Addendum No. 02

Memorial Stadium Modernization

Fieldhouse & Stadium

MADERA UNIFIED BID NO.: 073025
PBK PROJECT NO.: 20-51
DSA APPLICATION NO.: 02-121624 Fieldhouse
02-122784 Stadium

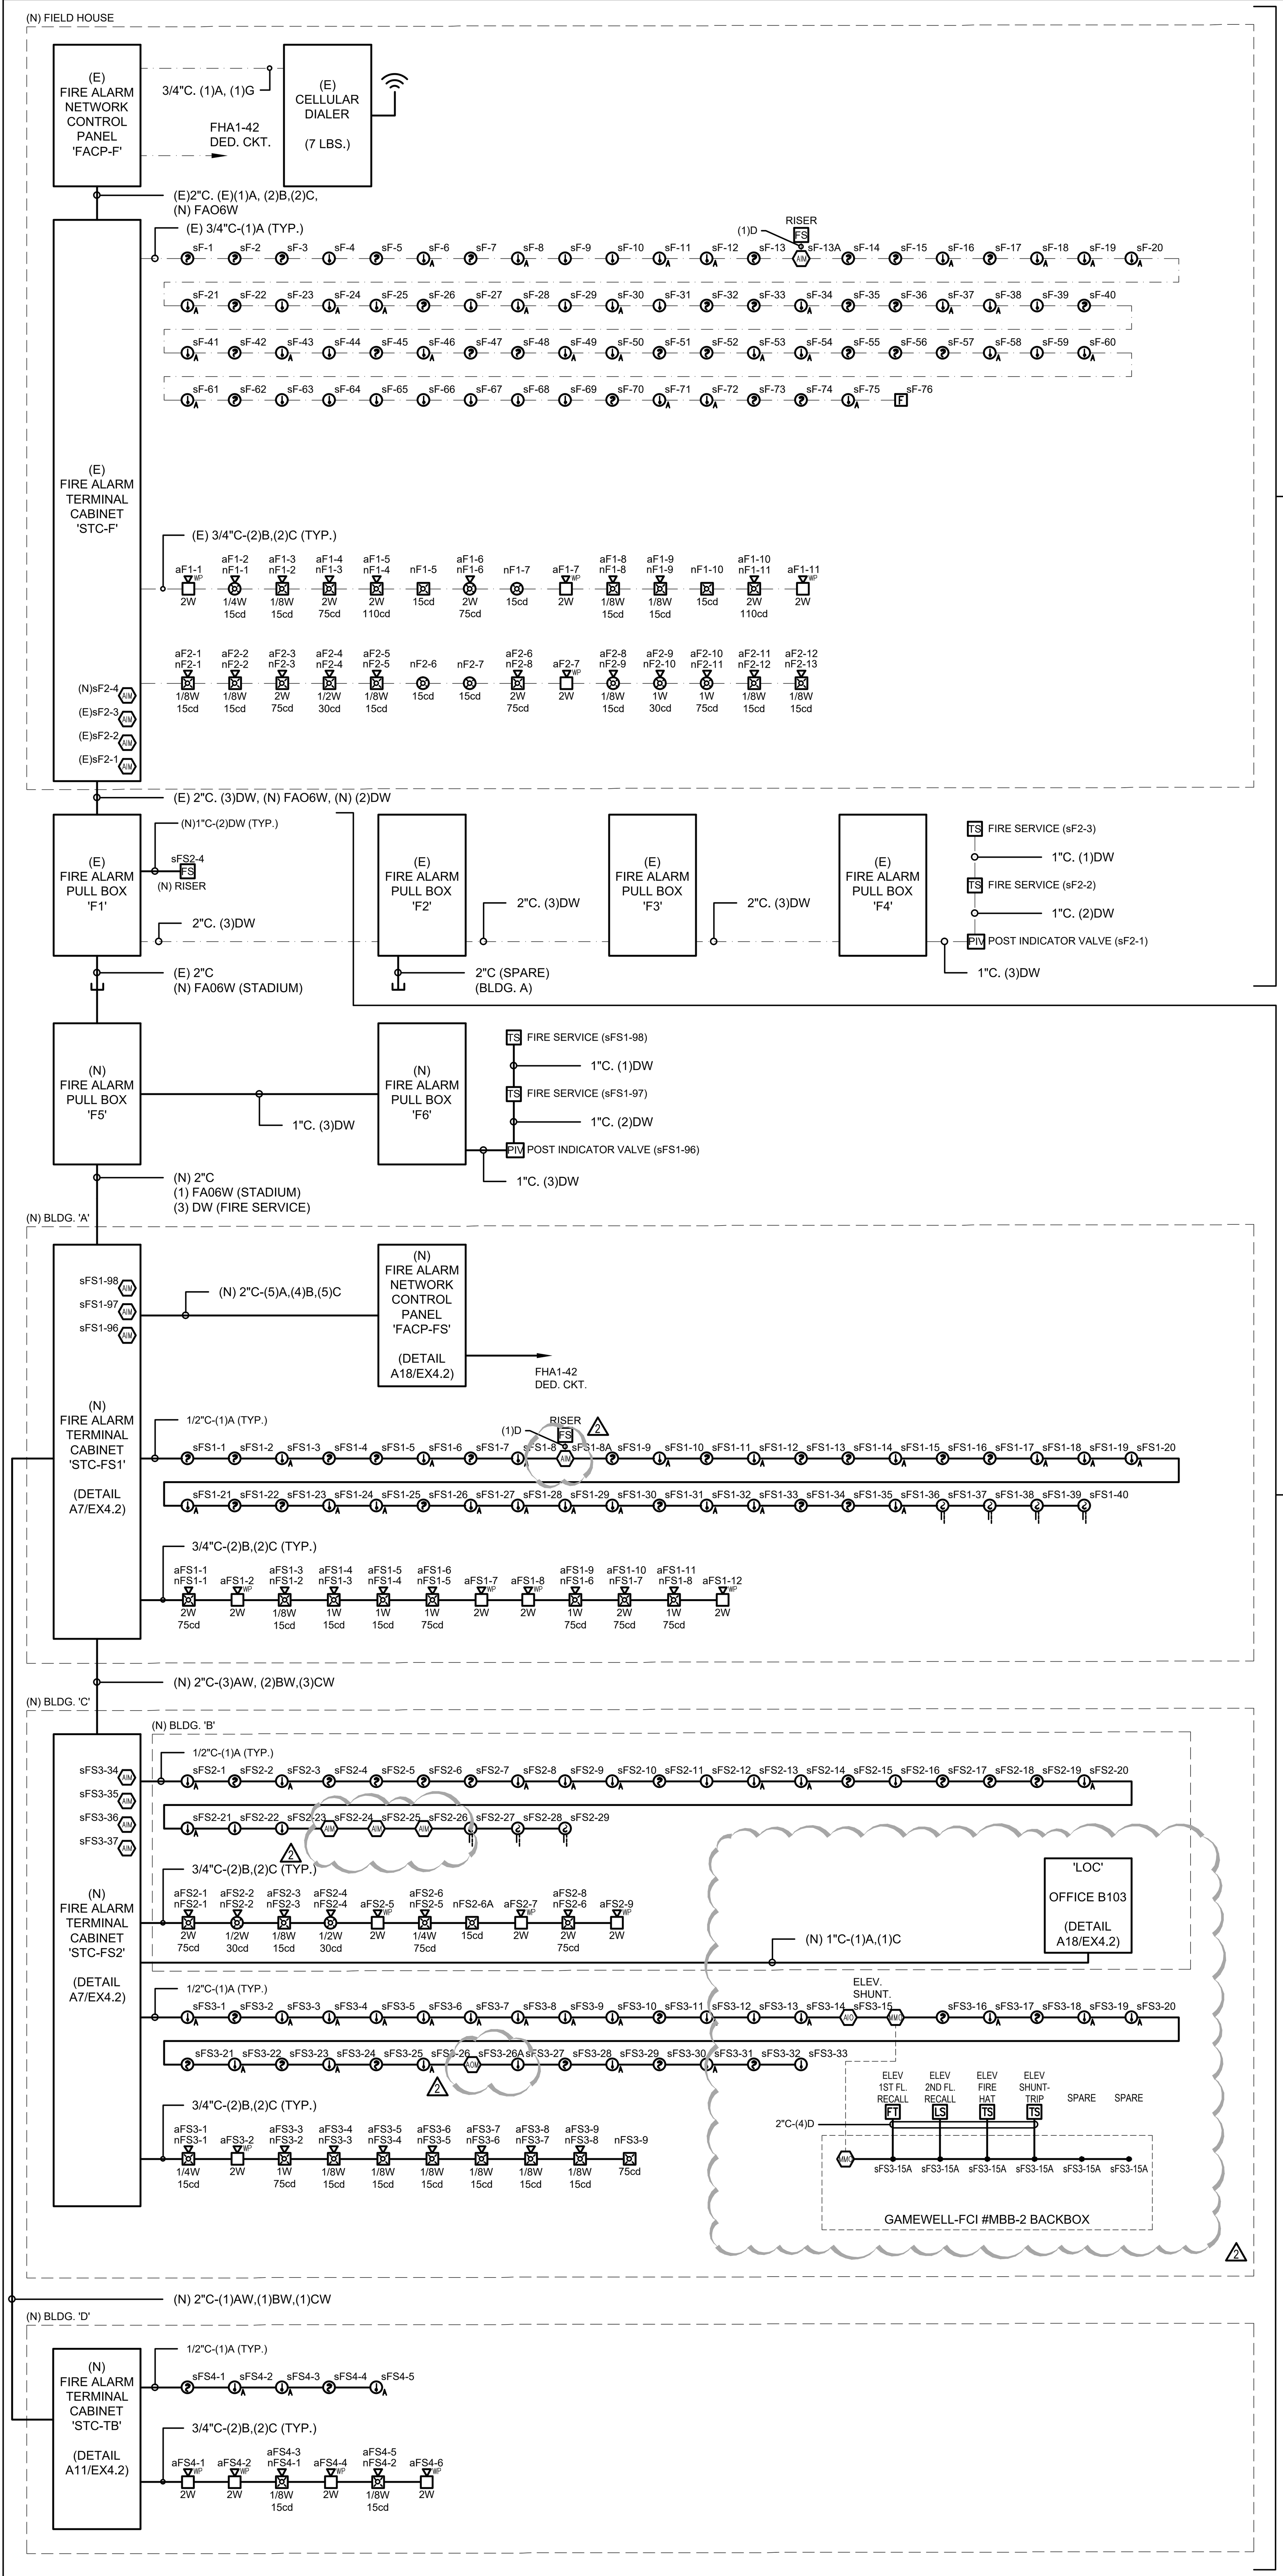
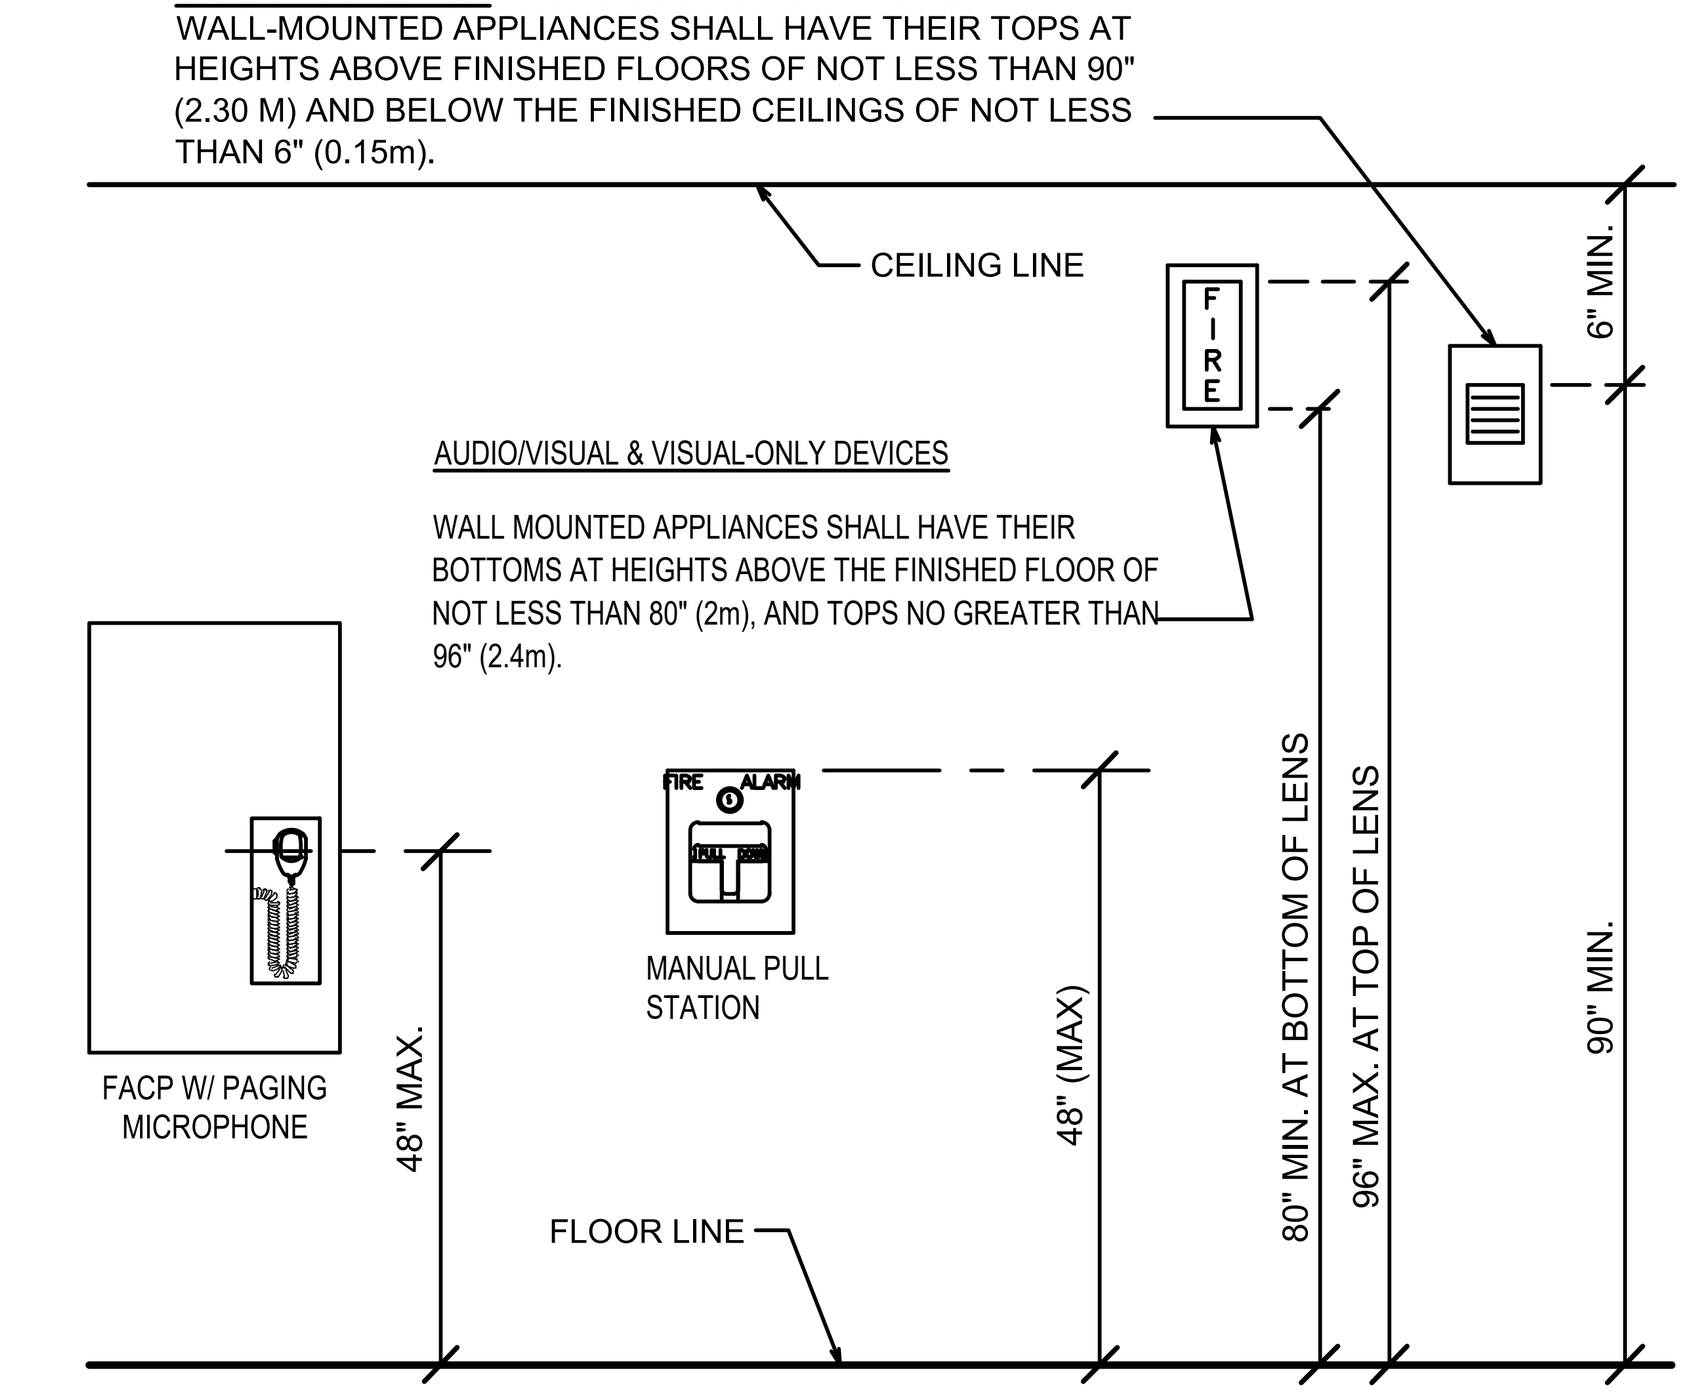
l. EX4.1 – FIRE ALARM
- Changed Fire Alarm to Gamewell E3 System. All Fire Alarm equipment has changed.
- Modified system to add Multi-Output card at elevator controller.
- Added Local Operators Console (at Coaches Office B103.
- Added note to install duct detectors below roof.
